Annex A Response to Departmental Comments

**S.16 Planning Application for Proposed Residential Institution (Student Hostel) in “Residential (Group C)”
with a minor portion within “Green Belt” Zones at Middleton Towers, 140 Pok Fu Lam Road (Rural Building Lot No. 825 RP)
and adjoining Government Land, Pok Fu Lam, Hong Kong**

Responses to Departmental Comments (Resubmission of 4th Batch)

Response to Departmental Comments – Application No. A/H10/98

Annex III - Swept Path Analysis of Proposed Shuttle Bus Services

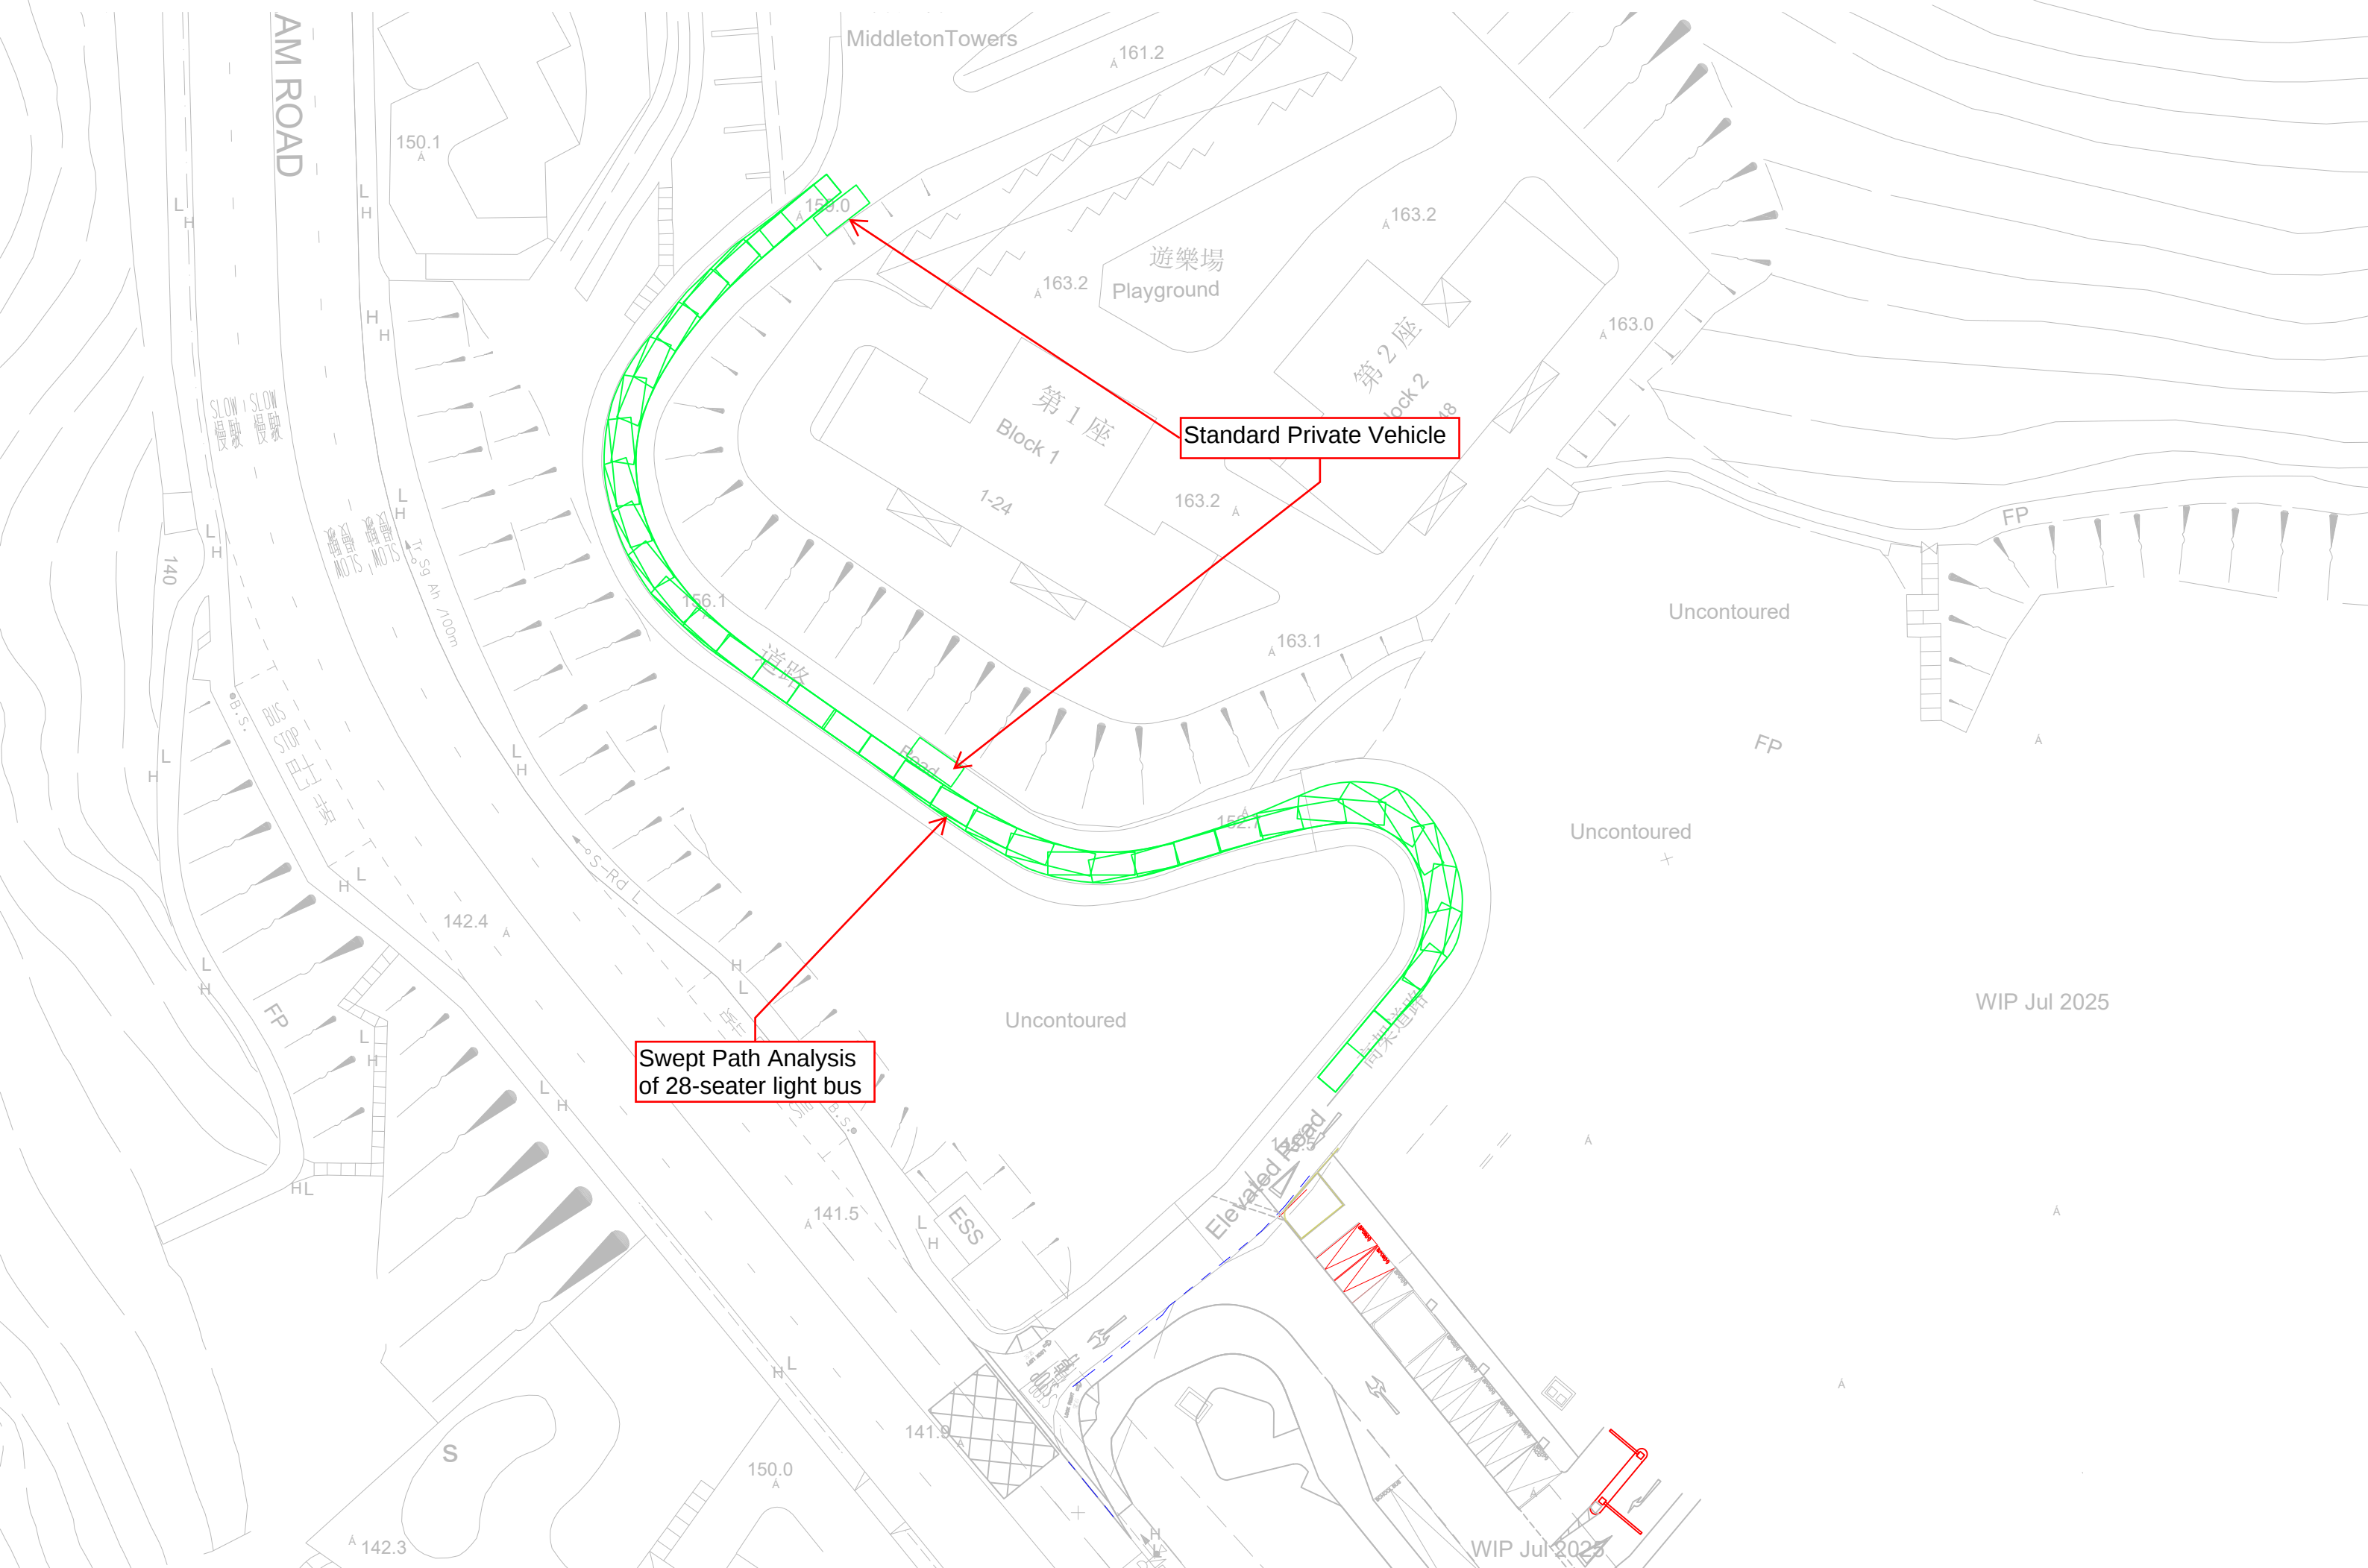
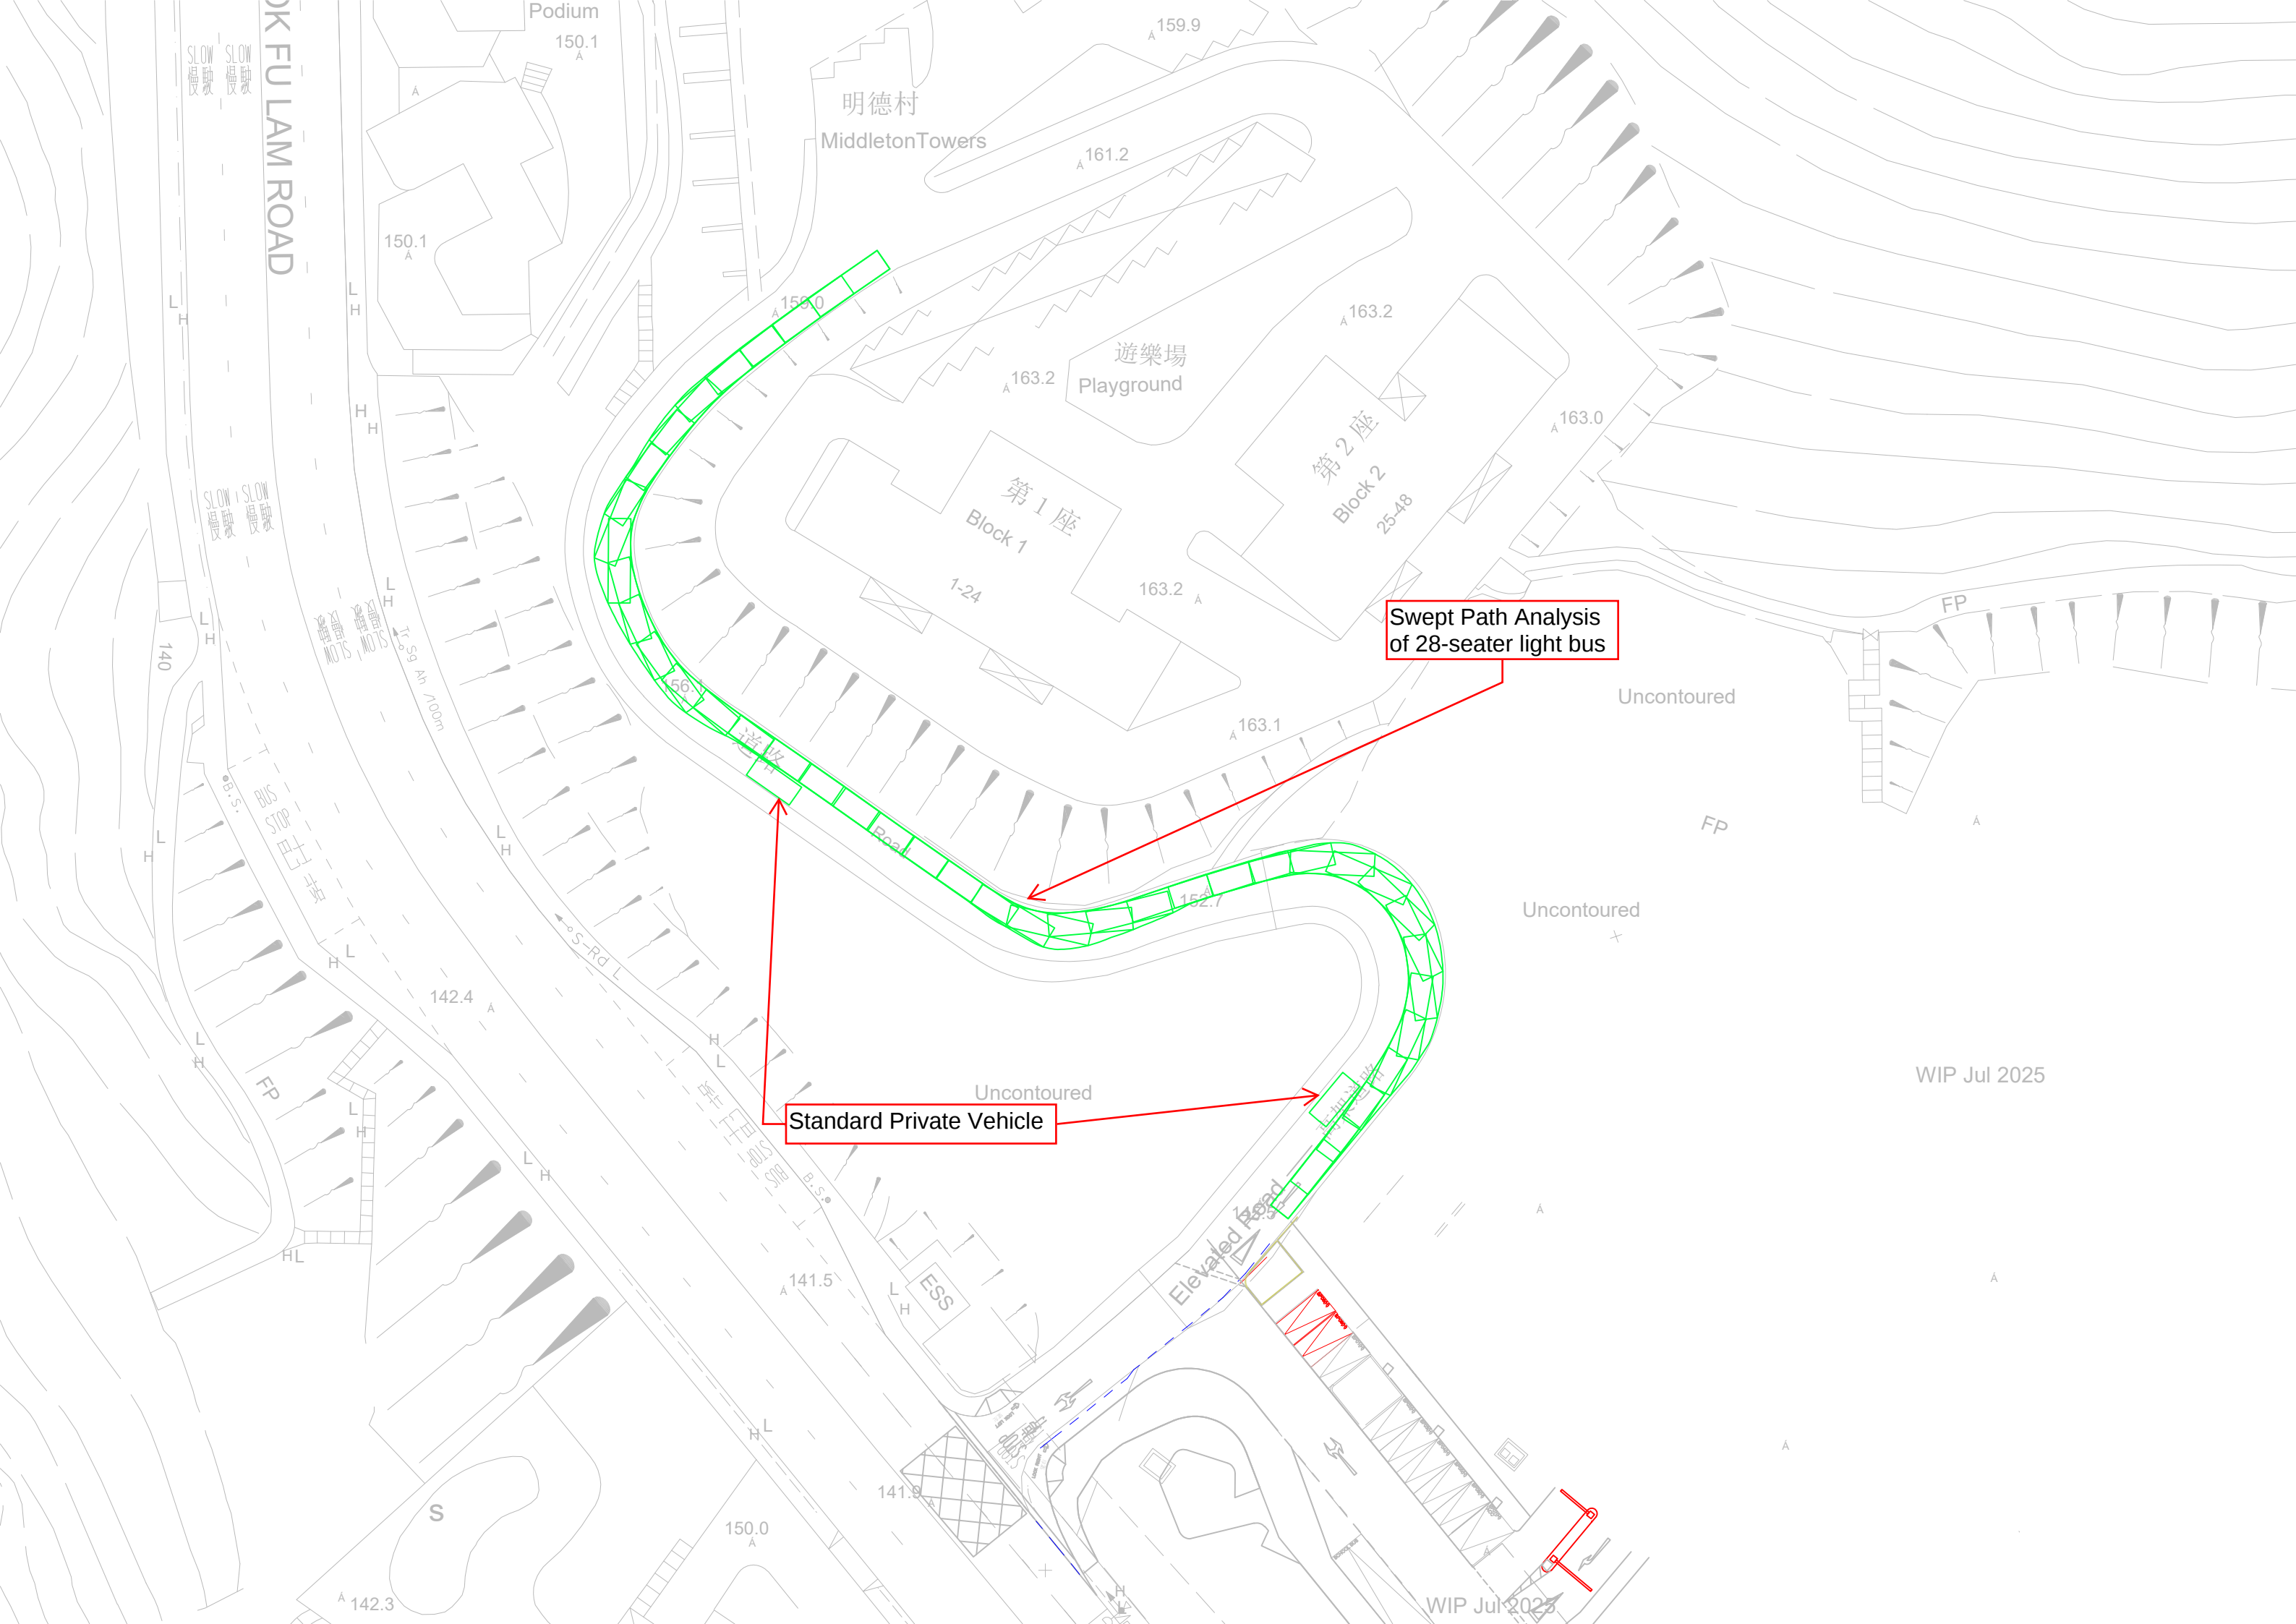
1.11.	(i) Further to the discussion in the meeting on 11.6.2026, please indicate the proposed shuttle bus stop for the proposed redevelopment in the drawing, advise the size of shuttle bus and provide the relevant swept path analysis to demonstrate that the proposed shuttle bus could maneuver smoothly to the redevelopment site for accessing the proposed shuttle bus stop.	The proposed shuttle bus stop will be located at the platform of Middleton Tower. The proposed bus services will operate with 28-seater light bus. Swept Path Analysis of this light bus is provided in Annex III of this RtC.
